CITY OF ALBUQUERQUE

April 24, 2018

RE: **Lot 16 Block 8 Unit 5 S.A.D. 227**
6208 Casas Blanca NW
Grading and Drainage Plan
Engineers Stamp Date 4/13/18 (E10D045)

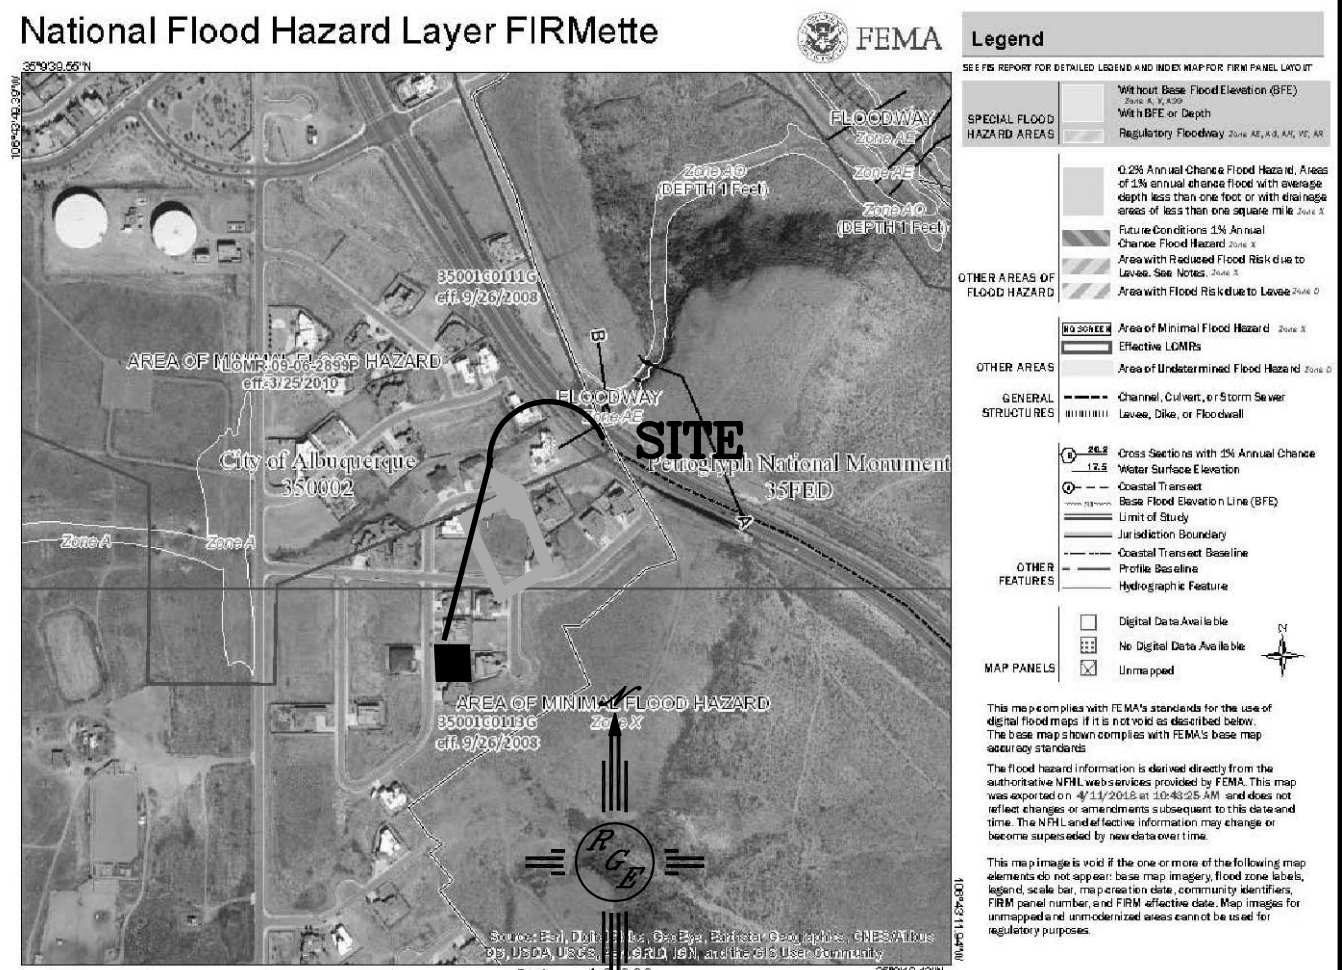
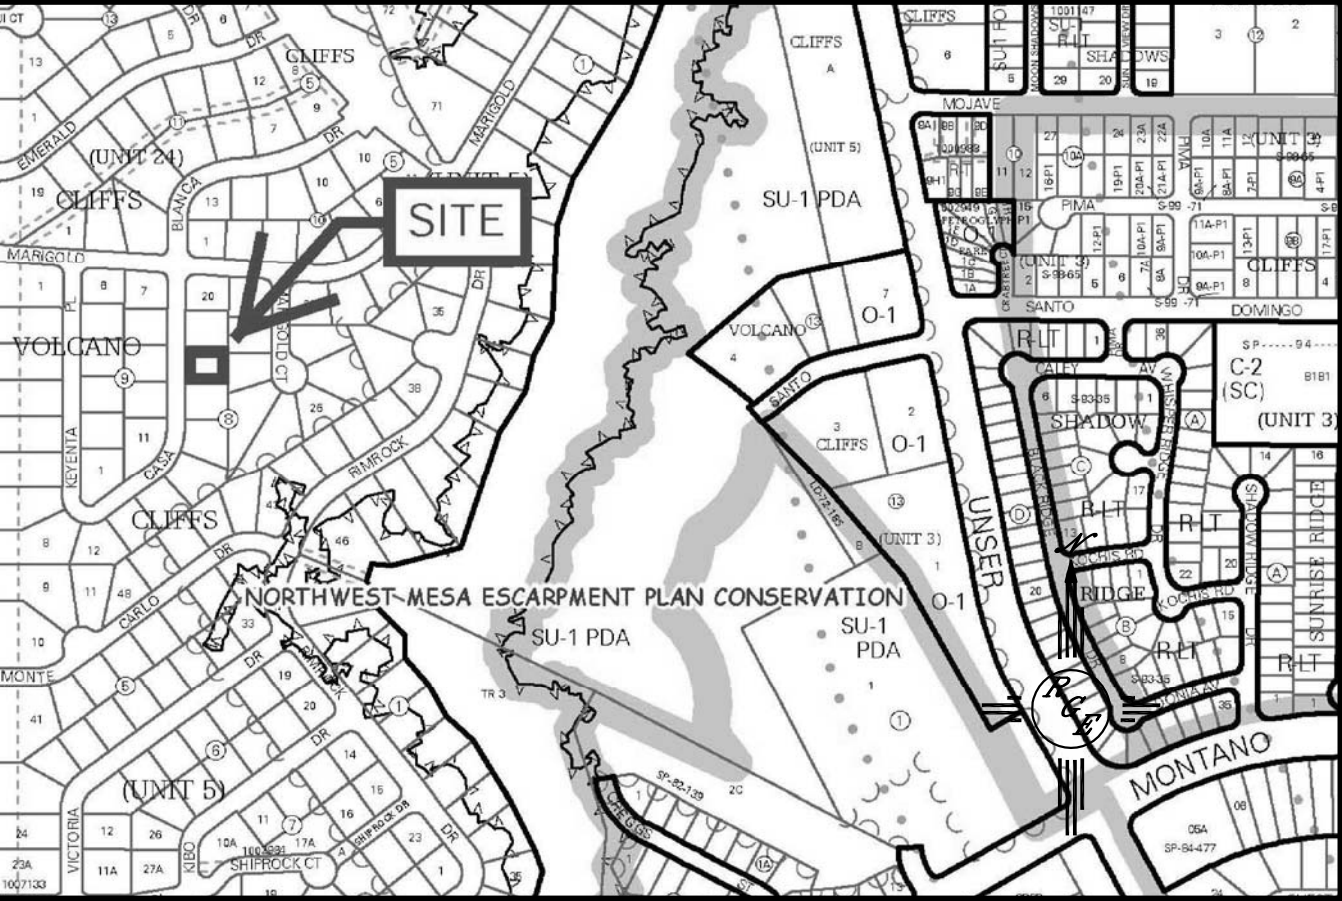
Based upon the information provided in your submittal received 4/13/18, this plan is approved for Grading Permit.

Reiterate to the Owner/Contractor that a separate permit for a garden/retaining wall must be obtained, with the approved G&D plan.

Prior to Building Permit approval, a **Pad Certification** will be required.

Prior to **Certificate of Occupancy release**, Engineer Certification per the DPM checklist of this plan will be required.
